APPLICATION NO.	FILING DATE	FIRST NAMED INVENTOR	ATTORNEY DOCKET NO.	CONFIRMATION NO.
10/780,914	02/17/2004	Milan Cerovic	101.00012	7564

DETAILED ACTION

Fig. 2

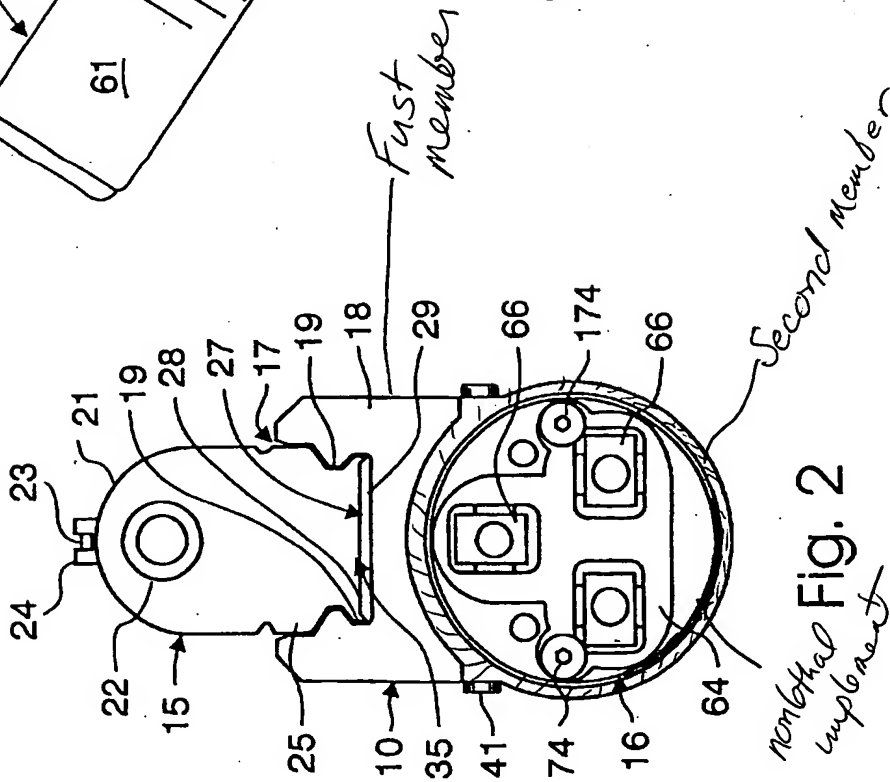
With regards to claims 18 and 19 Matthews et al. discloses a support that *has the ability to be* used to attach a non-lethal implement to a firearm that has a rail and a stop that is not part of the rail (it is noted that nearly any implement can be considered non-lethal), the support comprising: a first member, a second member coupled to the first member to form an assembly that *has the ability to hold* an implement between the first member and the second member, the assembly having a channel that *has the ability to receive* the rail and a fastener that restricts motion of the assembly with respect to the stop thereby restricting sliding of the channel with respect to the rail, wherein the fastener is manually releasable without using a tool (See examiner's notes on Figure 2).
